## **TECHNISCHE INFORMATION NR. SI36-035-1**

## **SERVICE INFORMATION NO. SI36-035-1**

All  
HK 36  
HK 36 R  
HK 36 TS  
HK 36 TC  
HK 36 TTS  
HK 36 TTC  
HK 36 TTC-ECO  
aircraft with ELT ACK Model E-01 installed

**SERVICE BULLETIN SB E-01.9**  
**December 12, 2006**  
**MODEL E-01 ELT AFFECTS ALL SERIAL NUMBERS**

Figure 1

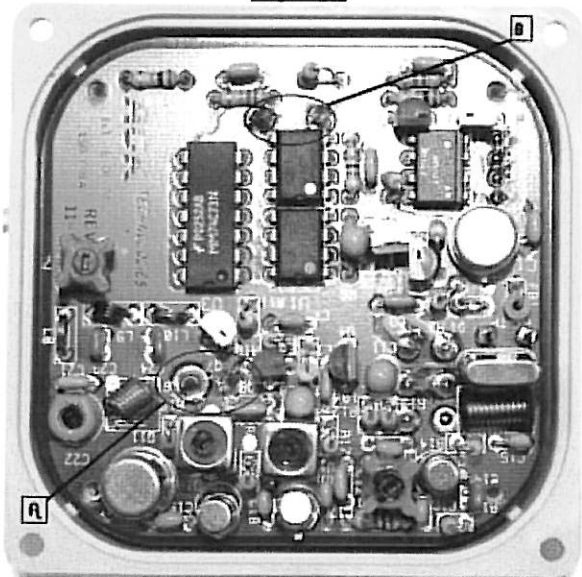
- 5.) Remove the 4 small Philips head screws in each corner of the circuit board.
- 6.) Locate and heat B&C connector and ground (Figure 1, Example A) while pushing on/off toggle switch to remove circuit board from component housing.

- 7.) De-solder B&C connector ground wire, and replace with new 3in. 20-22 gauge tinned copper wire.
- 8.) Remove 4 wire plug.
- 9.) De-solder G-switch noting lead positions. (Figure 1. Example B)
